Public Works Department – Engineering Division

ADDENDUM NO. 1

PROJECT 2019 BART PEDESTRIAN AND BIKE CONNECTIVITY

**BART PEDESTRIAN & BIKE
CONNECTIVITY PROJECT
EXISTING CONDITIONS EXHIBIT**

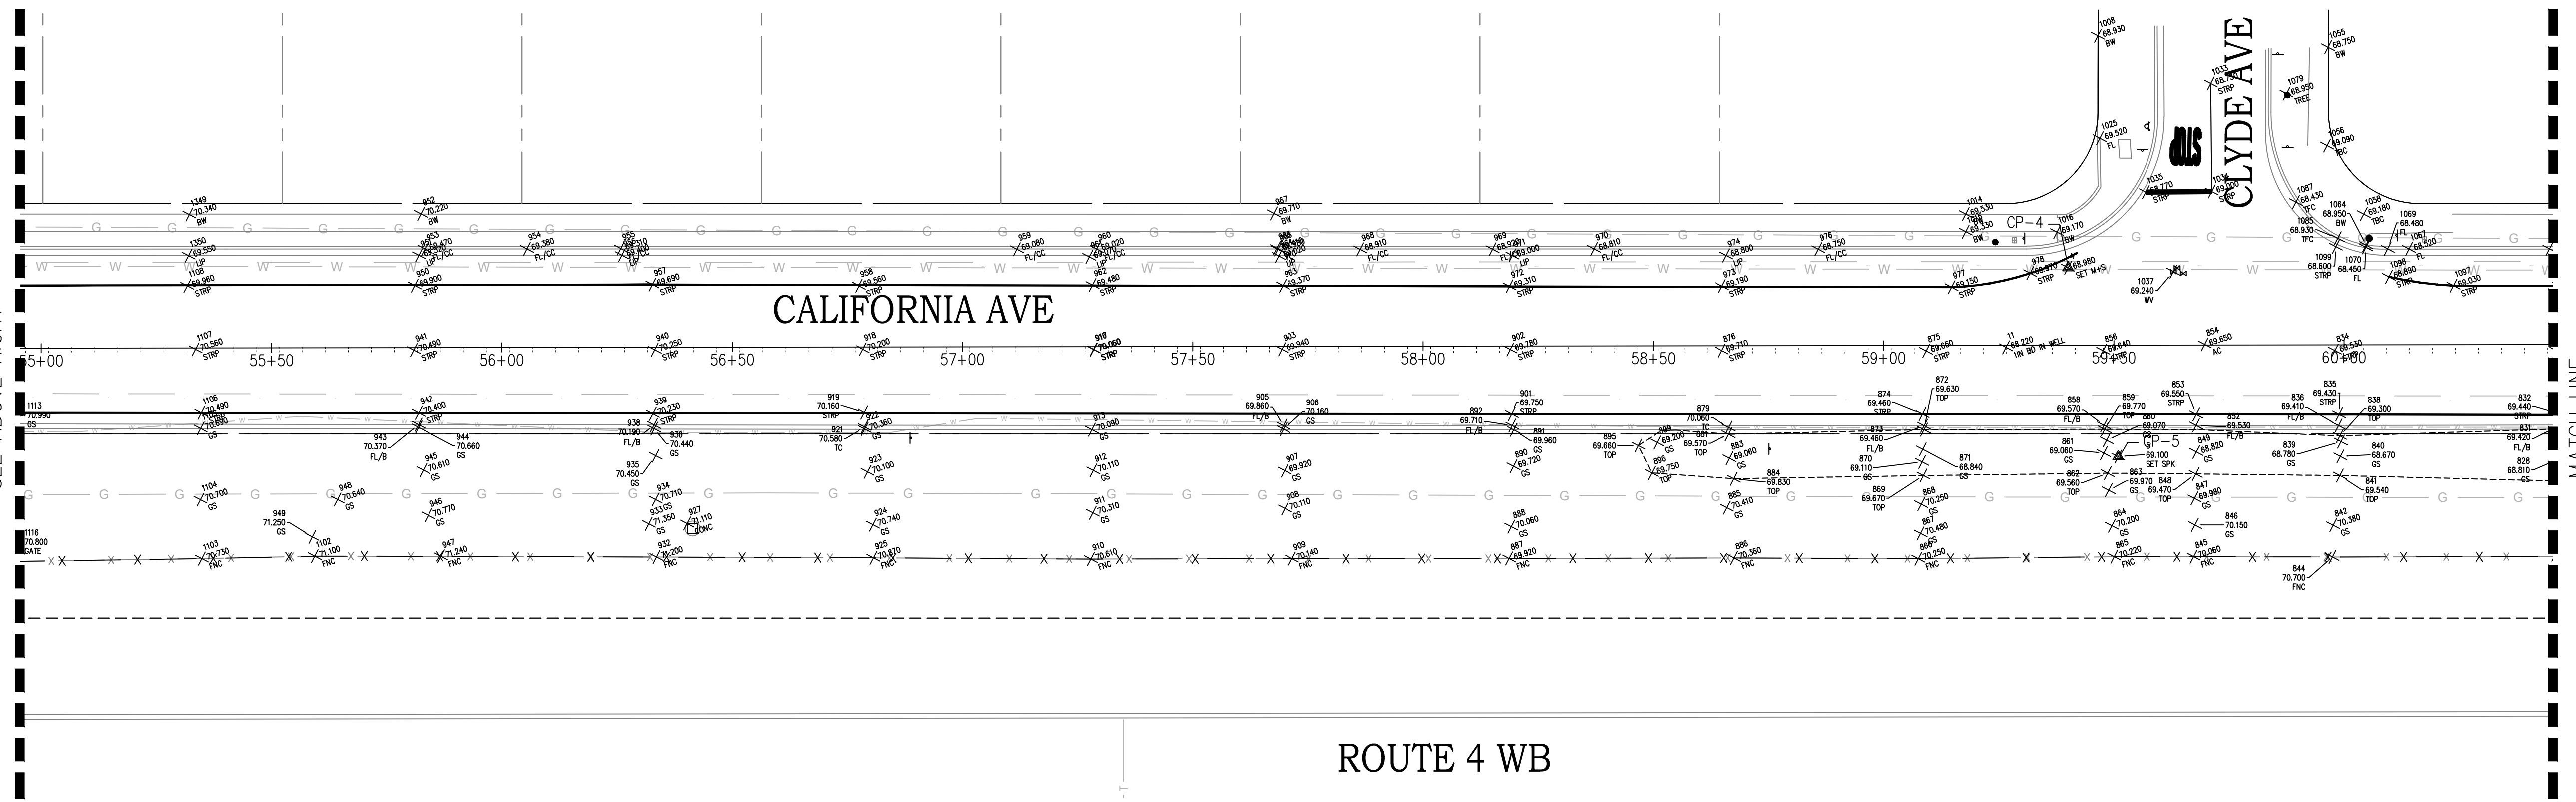
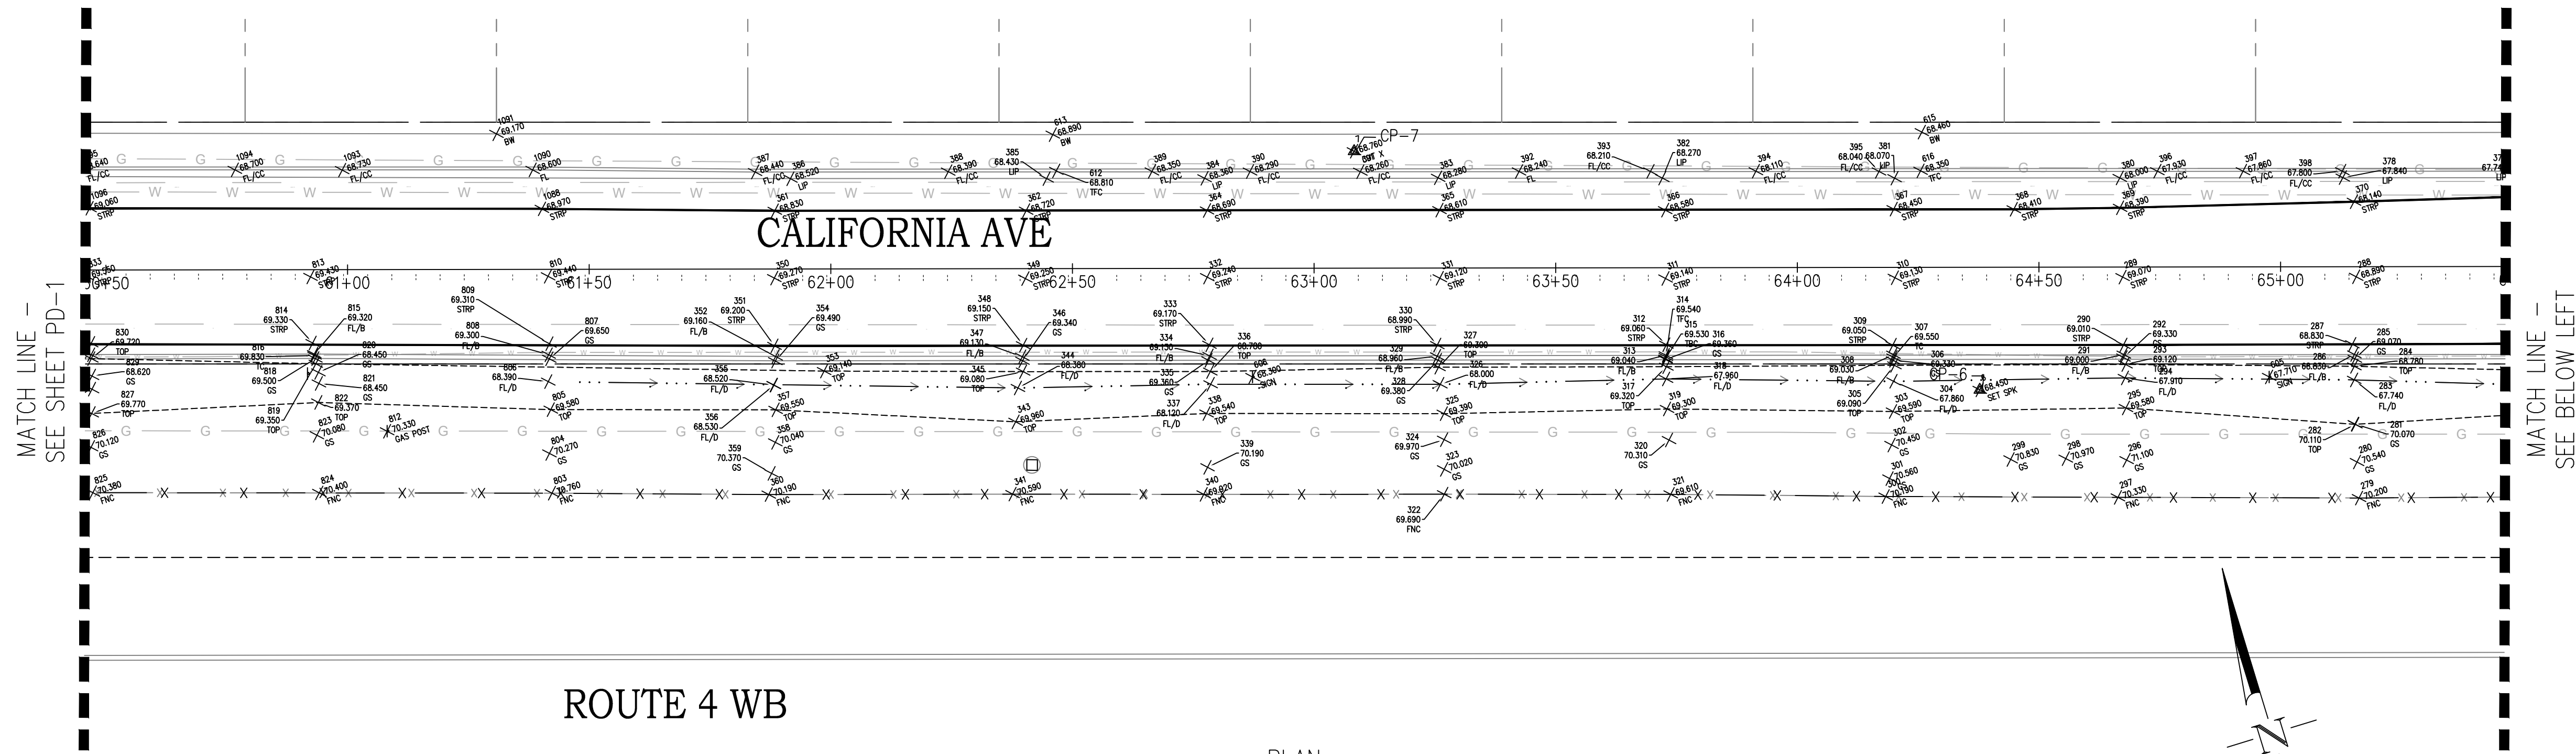
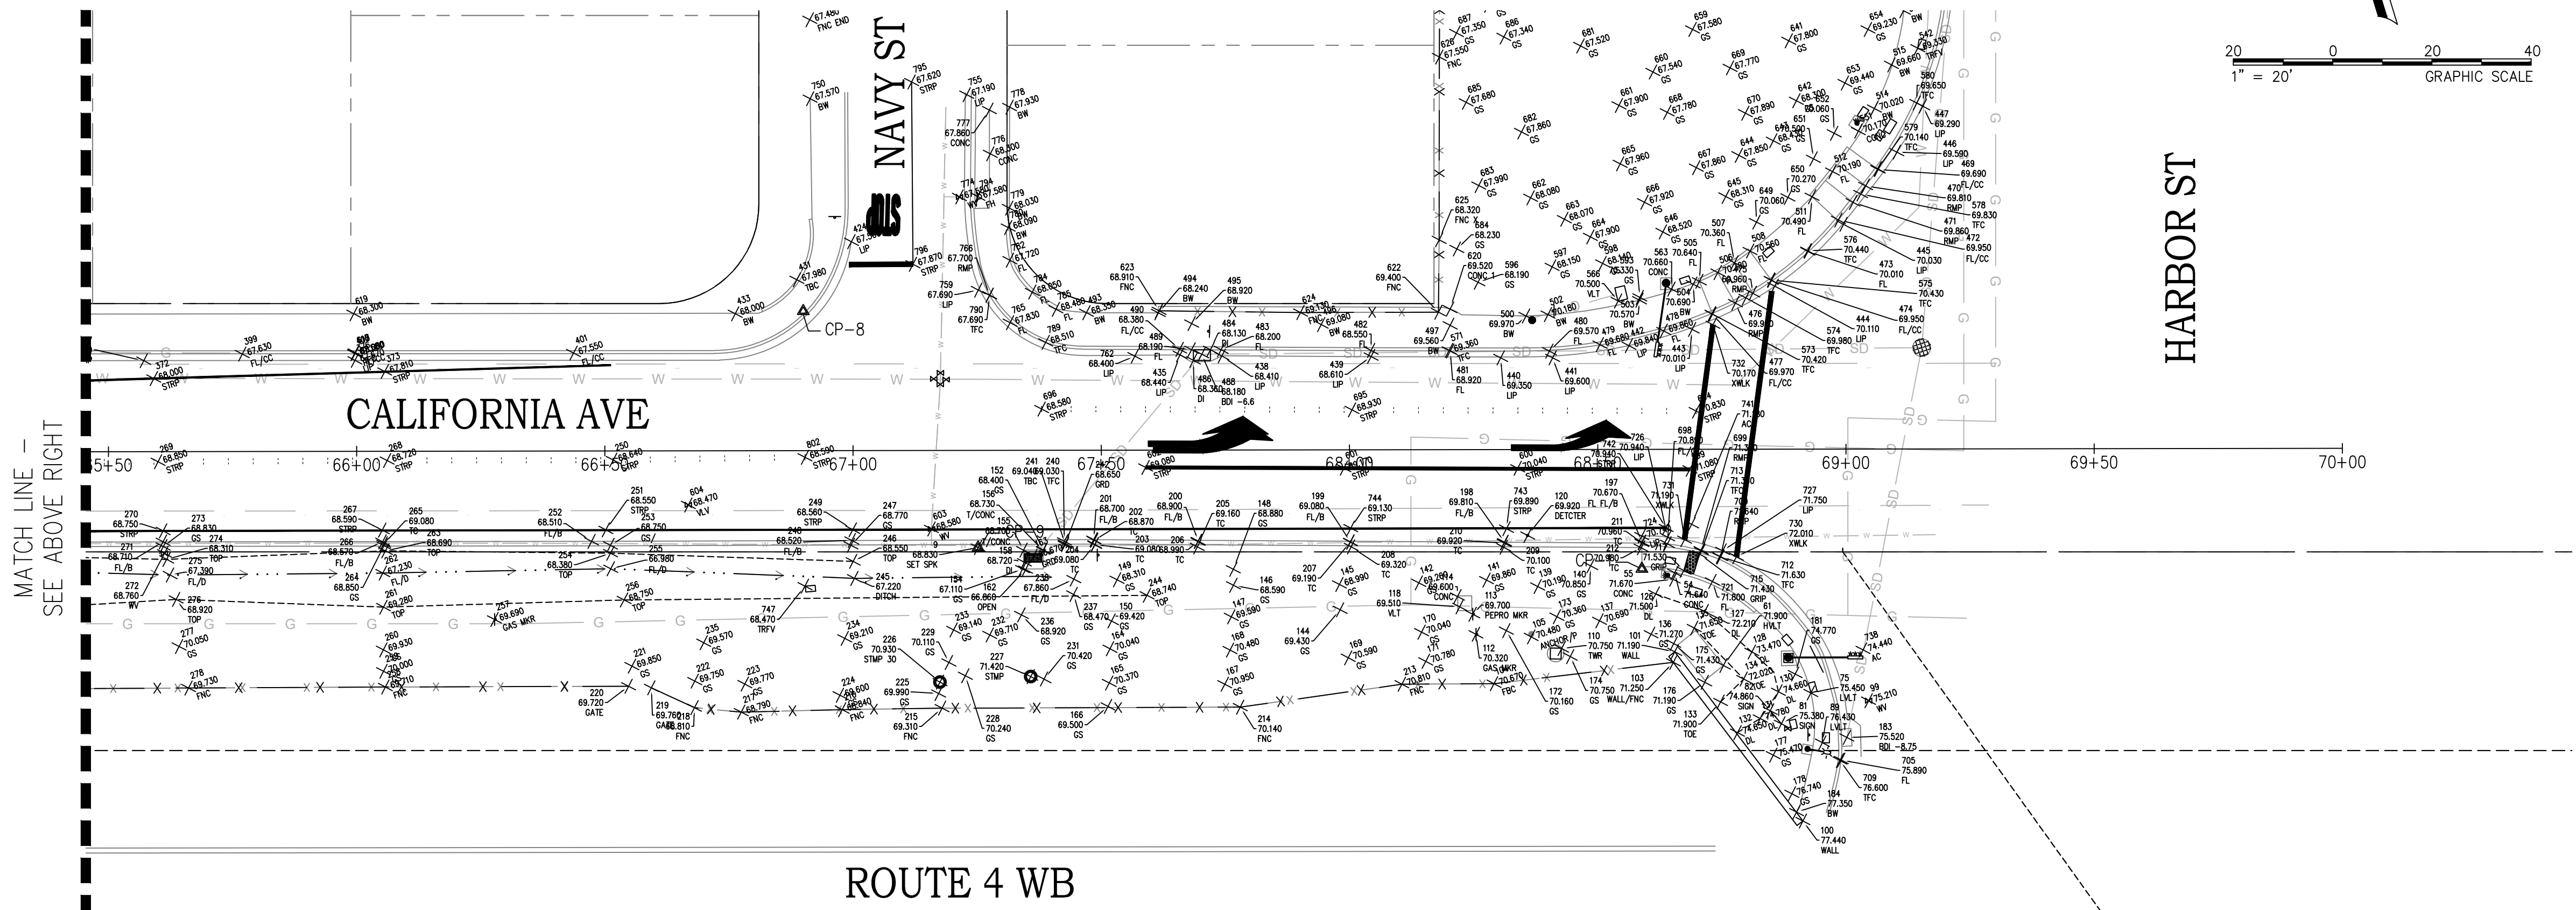
3. There are no existing elevations provided for earthwork calculations.?? Please provide existing elevations in order for bidders to accurately calculate roadway excavation quantities.

34. Can you please provide topographic plans or highway sections showing the existing and proposed grades.

Existing Condition exhibits have been added for reference information, see attachment B.

Existing Conditions Plans are attached.

A
 X-1
 PROPOSED SECTION @ BART PARKING
 (CALIFORNIA AVENUE)
 LOOKING WEST TO EAST

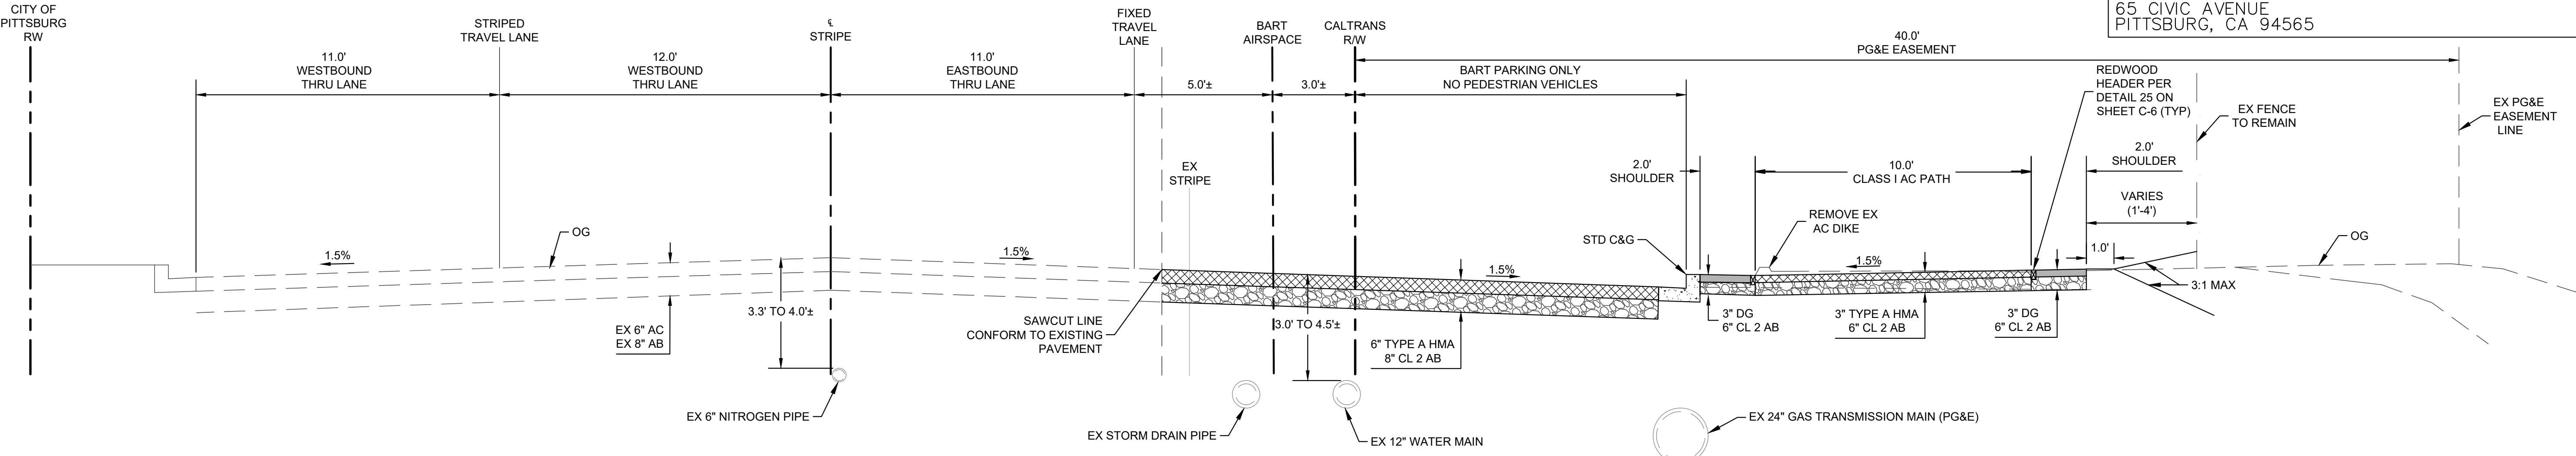
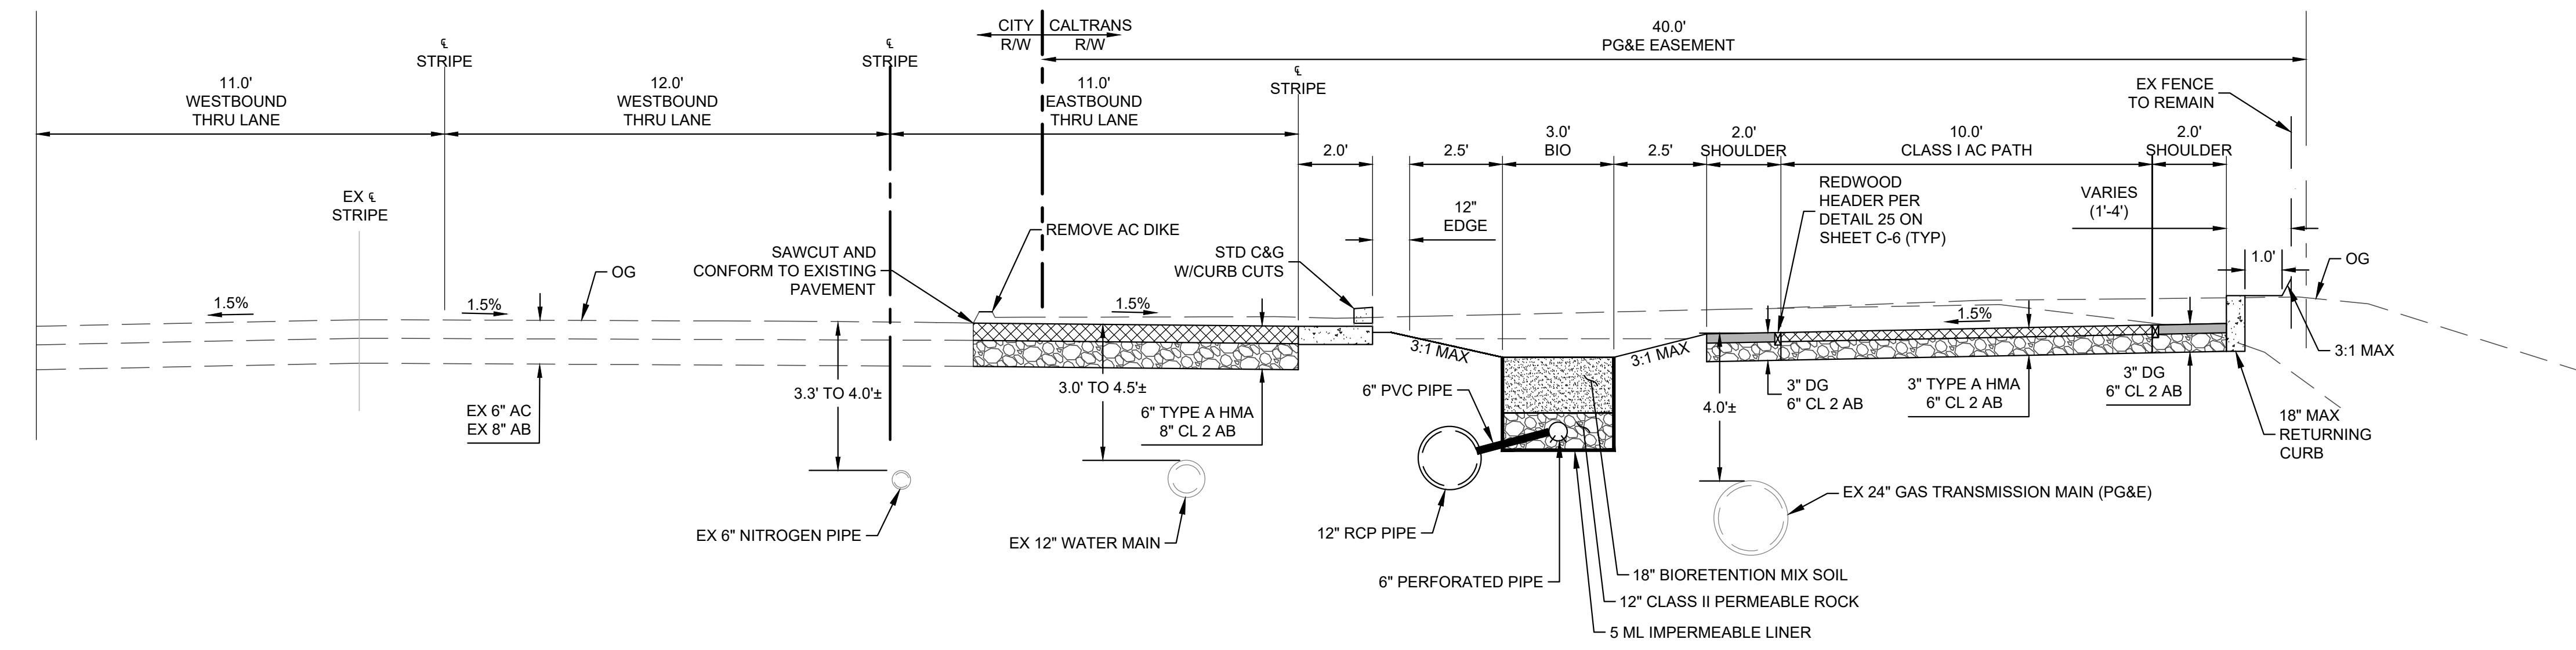
5. No headers are shown to be installed at the DG and asphalt pathways on the X-1? X-3 typical sections. Please confirm that this is correct?

A redwood header shall be installed at both sides of the 10' class I AC path. Bid schedule has been revised to include this item as #62 for California Avenue and #173 for Railroad Avenue. See attachment A for revised bid schedule.
